County of Bernalillo
State of New Mexico
Public Works Division

Date: June 16, 2022

Subject: Bernalillo County Regional Recreation Complex (BCRRC), Mesa del Sol Traffic Impact Study

Below are Bernalillo County comments on the subject draft TIS dated April 18, 2022. Please address these comments for the subsequent submittal.

INTERSECTION 2 – ACCESS 2 & UNIVERSITY BLVD.

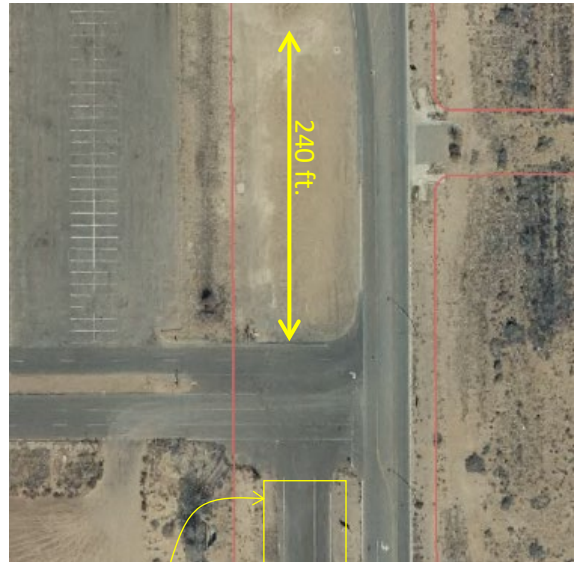
- a. There appears to be sufficient ROW for SB right-turn lane. This improvement needs to be required with substantial completion of the BCRRC or with full build out of University Blvd as part of the Mesa del Sol Level B Master plan, whichever comes first.

- b. The 2026 analysis provides a NB left lane. At this intersection the TWLTL converts to a SB left. There is no NB left lane. Although there is not many NBL turns, the analysis should accurately depict current conditions.

- c. The 2036 Mitigated analysis also provides a NBL. This center median area currently serves SBL to Fritts Crossing. This area cannot be a TWLTL due to conflicting lefts. Address which left turns the center turn lane will accommodate.

- d. EBL Configuration: There is a second EBL that cannot be used. Should it go away?
- e. There are two receiving lanes into the site. Should they both be included?

- f. The Bobby Foster frontage road that runs parallel to University Blvd will be closed further south. There should be some form of closure to keep motorists from making EBR turns at this location when the Montage Units improvements go to construction.

This two-way access road will no longer be available with the Montage Units offsite improvements
